24 February 2026
Job No: 1101840.0000

Takitumu Northern Link Stage 2 Stormwater/flooding review

Figure 3.1: Works area showing modelled outputs (yellow highlight)

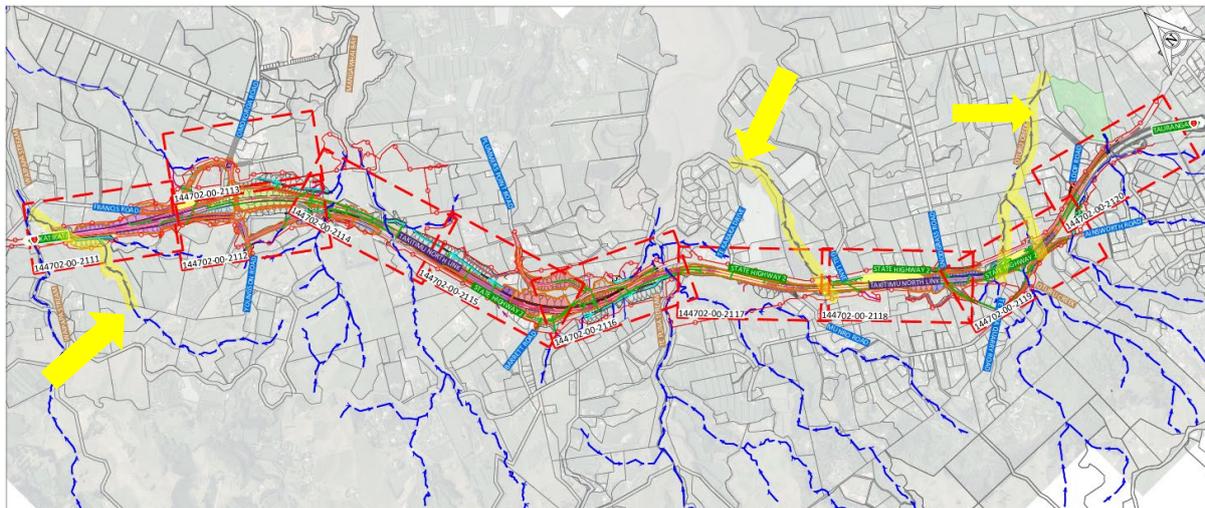
Flood mapping provided does not appear to cover all areas within the work site. There are numerous instances where changes to the flood performance in waterways are anticipated as a result of the proposed works (e.g. stream diversions). However, most of these areas are within the current designation. Where flood effects are likely to be adverse (i.e. higher flood levels) outside of the designation, modelling has been used to assess and quantify those effects.

In Figure 3.1 a plan of the proposed works site is shown, with yellow highlighting to show the areas for which modelled effects outputs have been provided.

Flood effects have been assessed quantitatively (using a model) for streams downstream of the new proposed motorway and qualitatively upstream of the proposed motorway. Where existing cross drainage has been upgraded, the qualitative assessment has it that, due to increased conveyance under the proposed motorway corridor, upstream flood effects should always be reduced. In most cases the existing drainage under SH2 has been shown to be a choke point for flood flows, and backing up upstream of each culvert was expected (and has been observed). The proposed works

Figure 3.2: Mapped flood extents from model (blue is pre, yellow is post proposed works)

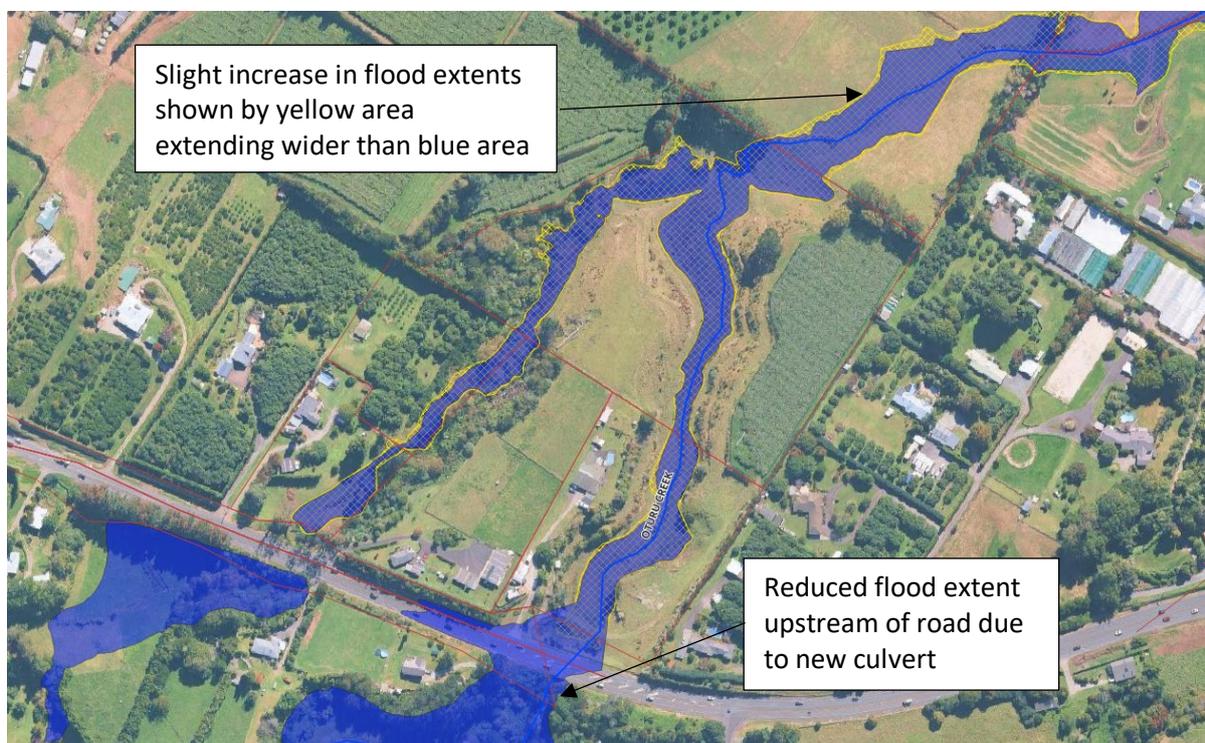
An explanation of the flood mapping procedure has been provided and following our review we agree that this is sufficient for the consent application. GIS files provided by the applicant have been examined, and differences in flood performance outside of the designation have been shown to be small. An example is shown in Figure 3.2.

Figure 3.3: Example of flood extent differences downstream of proposed motorway

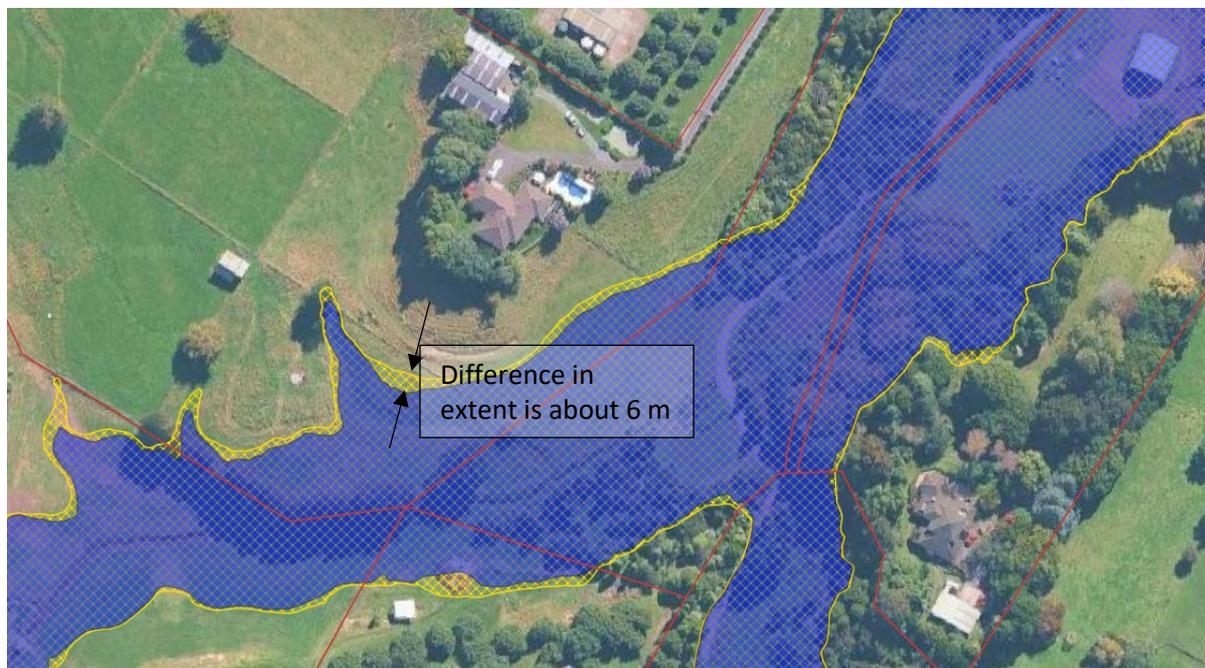
In Figure 3.3 a zoomed in plot of flood extents is shown. In blue is the flood extent under existing conditions (without the proposed motorway) and in yellow hatch is the flood extent for the same event, but with the proposed motorway in place. As can be seen, there is an increase in flood extent (and therefore level) that has been modelled to occur under the proposed conditions for the area shown. This area is downstream of the proposed motorway and the mapped increase is small. Detailed inspection over all of the modelled areas has revealed similarly small differences.

After detailed examination of (1) the methodology applied to map flood extents and (2) the magnitude of the differences in flood performance due to the proposed works, we agree with the applicant's assertion that the downstream effects are small.
